2150 LAKE SHORE BOULEVARD WEST PROPOSED MIXED-USE DEVELOPMENT TORONTO, ONTARIO

Urban Transportation Considerations
Official Plan Amendment, Zoning By-law Amendment, and Draft Plan
of Subdivision Application Resubmission
Technical Study

February 2021

FIGURE 3 - FUNCTIONAL ROAD PLAN

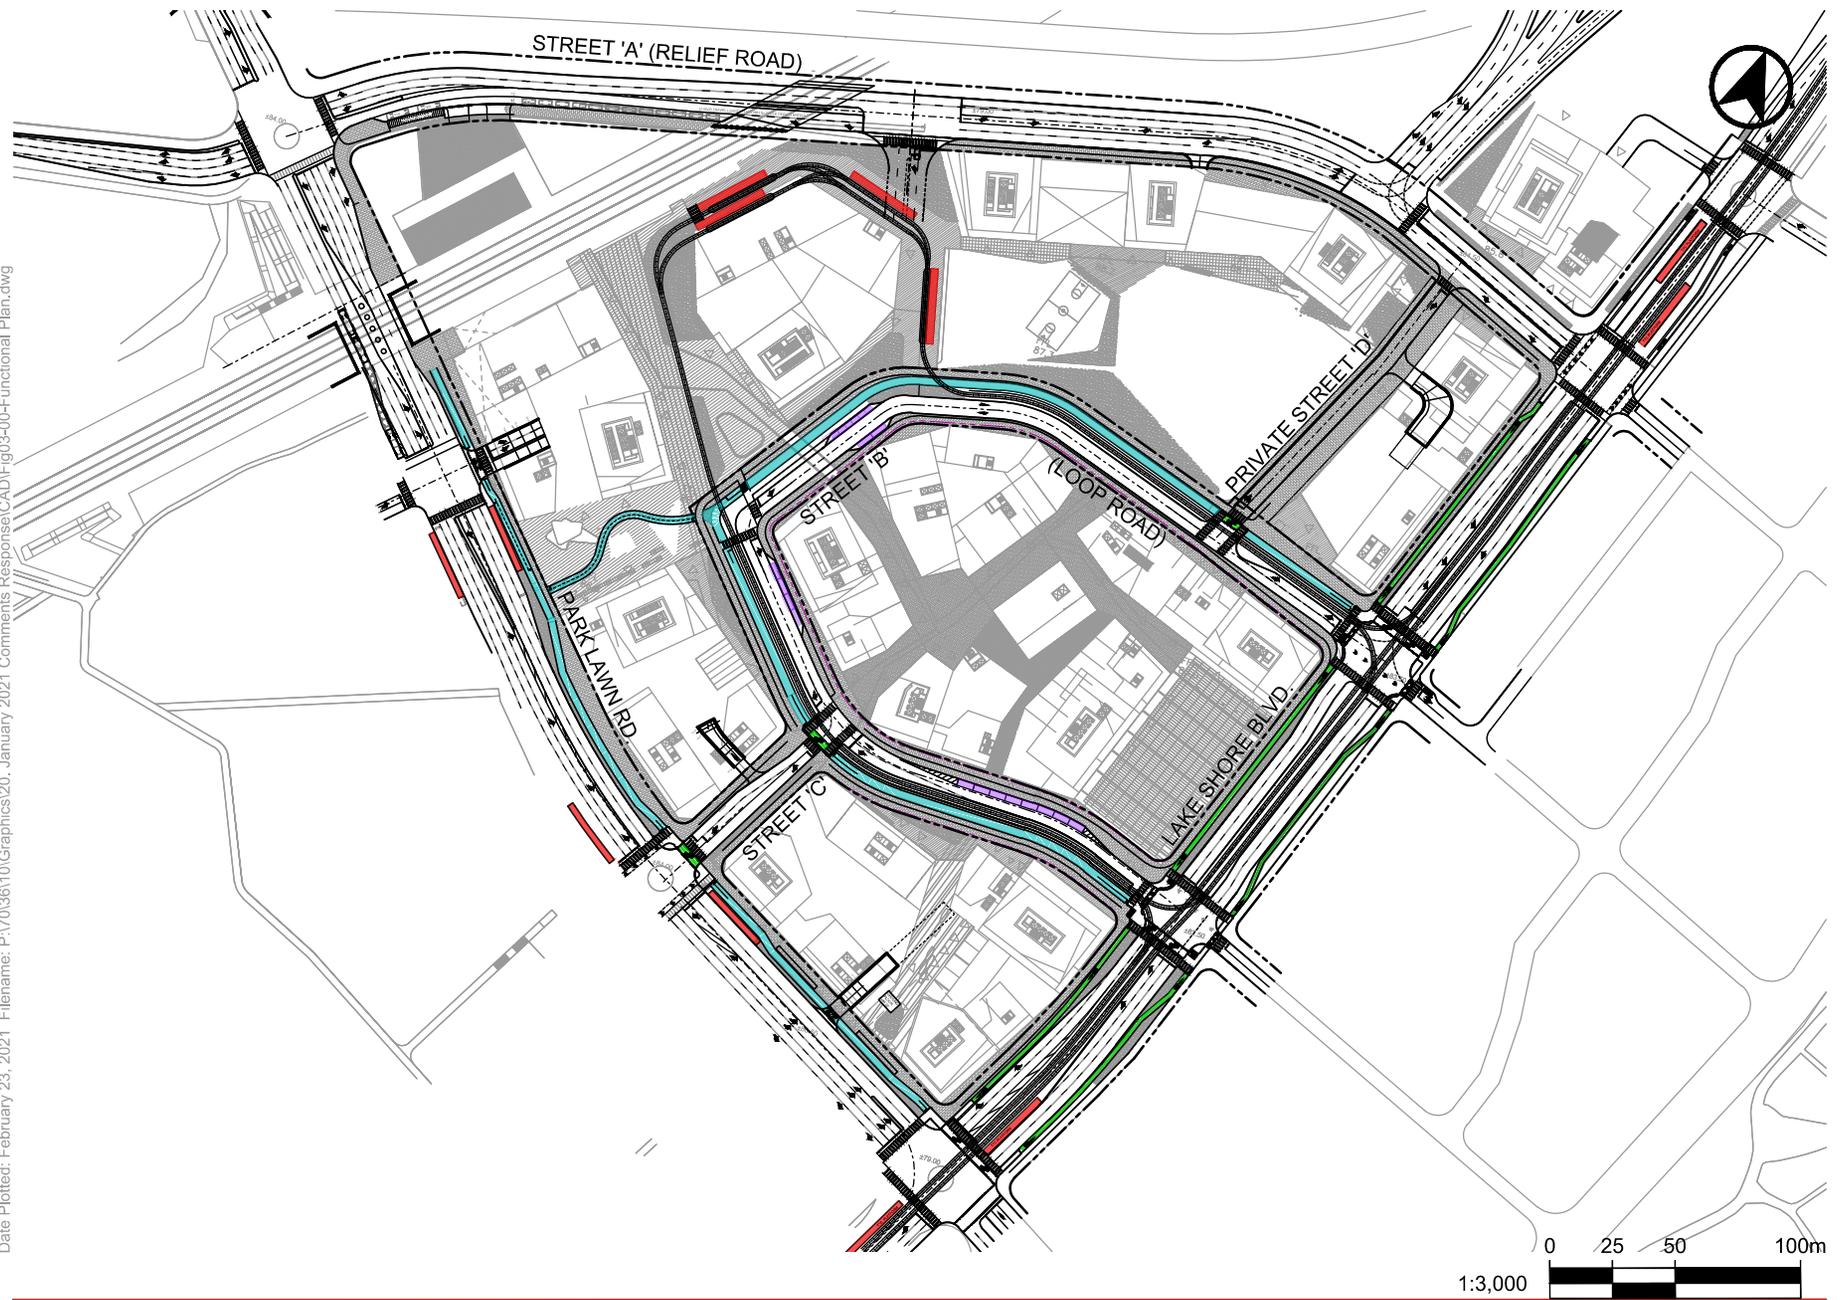
SP-27 Figure 3 – Remove routes 176 and 145 from the map
